Technical Service Bulletin

SUBJECT: LOAD CARRYING CAPACITY REDUCED LABEL – REVISED	No: TSB–18–00–003
	DATE: April 2018
	MODEL: All Models

***This bulletin supercedes* TSB–17–00–001*, issued March, 2017, to add updated information. Revisions are italicized and indicated by* ◀.**

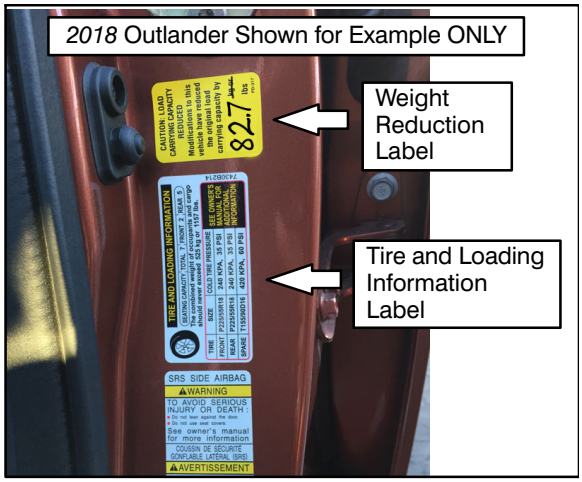
Using this example, the net weight of accessories added to the vehicle is greater than the weight threshold, so a Load Carrying Capacity Reduced label must be installed showing the capacity has been reduced by *82.7 lbs (37.5 kg).*

b. Write the total reduction in load carrying capacity (in either lbs or kg) with a permanent, fine tipped, marking pen. Draw a line through the unused weight unit of measure (lbs or kg).

- Apply the label in the driver's door jamb, within 25 mm (approx. 1 inch) of the Tire and Loading Information label.
  If a label is already in place due to port installed accessories, apply your label displaying the combined weight of the port installed and dealer installed accessories over any existing label.
- At the time of sale, the customer must be informed of a reduction in the vehicle's load carrying capacity, and be shown the label indicating the amount of reduction.
